SERVICE BULLETIN #1076

MODEL 1-80

SUBJECT CORRECT CLUTCH ROTOR REPLACEMENT

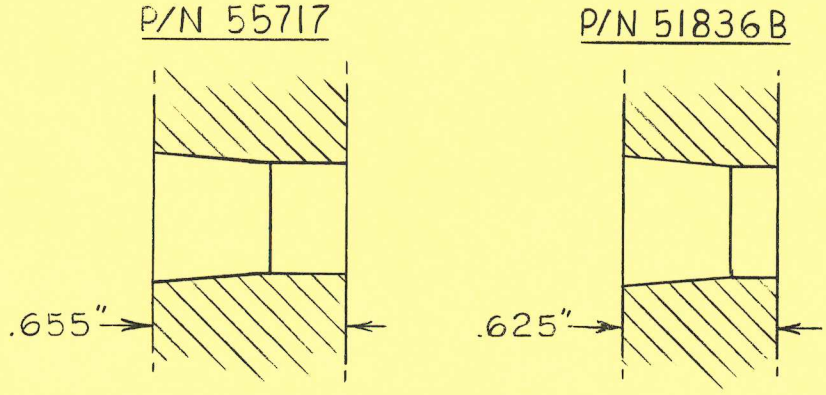
When replacement of the Clutch Rotor and Pawl Assembly, P/N 55717, is required on Model 1-80 saw engines, always install a new P/N 55717 Clutch Rotor and Pawl Assembly. Do not replace P/N 55717 with the earlier clutch rotor and pawl assembly, P/N 51836B (used only on 55 series engines).

The internal taper difference between the new 55717 and the earlier 51836B assemblies is too great and serious clutch damage will result if the 51836B rotor and pawl assembly is installed on Model 1-80 engines.

NOTE: P/N 55717, Rotor and Pawl Assembly, can be used on Model 1-80 and all 55 series engines.

P/N 51836B, rotor and pawl assembly, can be used only on all 55 series engines.
